**Subject:** Fuel Cap Tether Strap

**Models:** Chevrolet Express/GMC Savana  
Cutaways with a service body installed

**Date:** December 13, 2012

**Revision** June 6, 2014

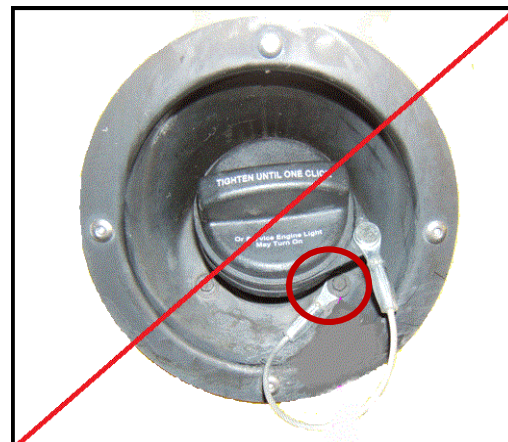
A condition may be caused by the fuel cap tether binding when installing the fuel cap and not allowing the fuel cap to seal completely or by the fuel cap tether being trapped between the fuel cap seal and the fuel fill pipe, not allowing the fuel cap to seal completely, possibly resulting in a Service Engine Soon Light being illuminated.

To avoid the above noted condition, all vehicles with a service body installed and using a stainless steel tethered fuel cap (9B4) should tether the cap as shown below.

This

verses

Not This
